N 1/A2.2 FIRST FLOOR PLAN - DIMENSIONS AND OPENING TAGS
SCALE: 1/8" = 1'-0"

RFI NO. 7

Medical Office Building
Slidell, Louisiana

A2.2R

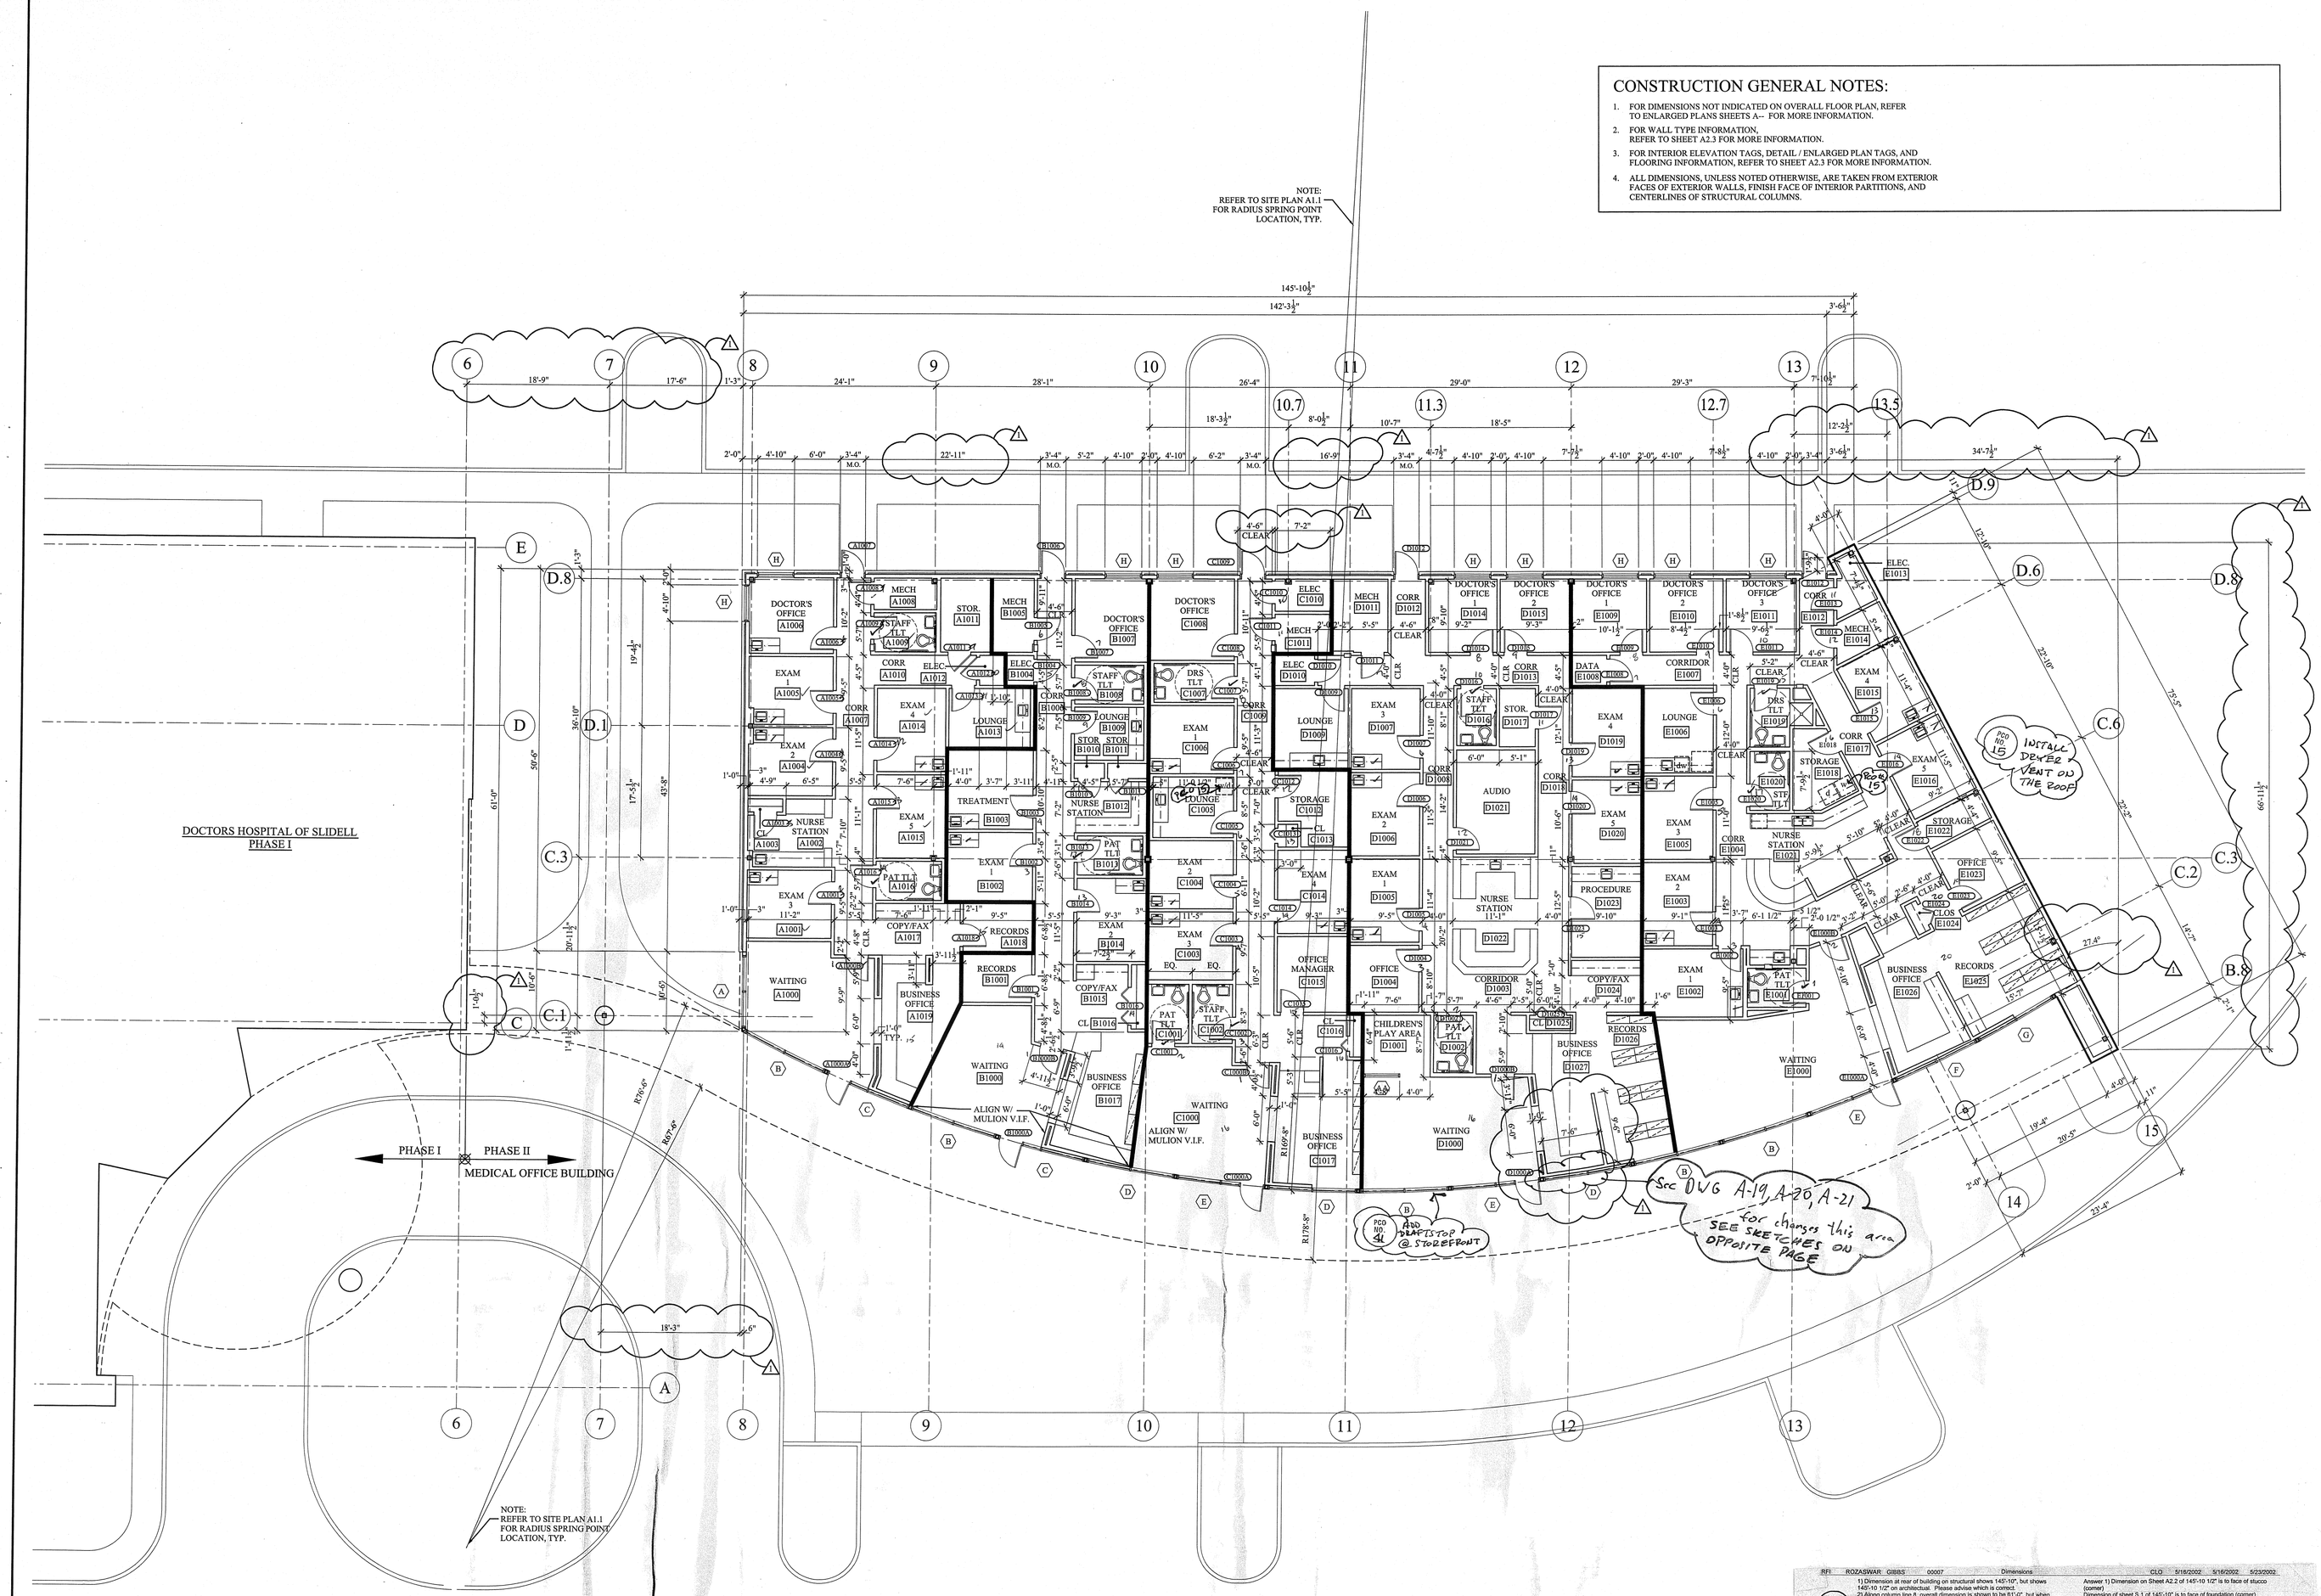
1) Dimension at rear of building on structural shows 140'-10", but shows 140'-10 1/2" on architectual. Please advise which is correct.
2) Along column line 8, overall dimension is shown to be 61'-0", but when individual dimensions are added the total is 61'-0 1/16". Please advise.
3) Please verify building to building dimensionsa well as offset between the two buildings.
4) Please supply details of canopy that runs between buildings.
a) Size of beams between W16x36's
b) Connection of W16x36's to new building
c) Connection of W16x36's to existing building.
d) Is W16x36 between radiused W18x36 below or between radius beams?
5) Please verify all clouded dimensions and conditions on Anchor Bolt Layout Drawing.

4) Please supply details of canopy that runs between buildings.
a) Size of beams between W16x36's Answer: 12K1
Joists @ elevation 113'-8 1/2"
b) Connection of W16x36's to new building
No answer yet, waiting on architect.
c) Connection of W16x36's to existing building.
No answer yet, waiting on architect.
d) Is W16x36 between radiused W16x36 below or between radius beams?
No answer yet, waiting on architect.

Answer 1) Dimension on Sheet A2.2 of 145'-10 1/2" is to face of stucco (corner)
Dimension of sheet S.1 of 140'-10" is to face of foundation (corner)
Answer 2) Overall dimension is 61'-0" as shown on shop drawing.
Answer 3) See anchor bolt shop drawing.

Answer 5) Verified on anchor bolt layout shop drawing.

5/31/02
Answer:
4) Detail of canopy between buildings:
a. 12K1 joists @ el. 113' - 8 1/2"
b. See attached drawing: S-3
c. See attached drawing: S-1
d. See attached drawing: S-2
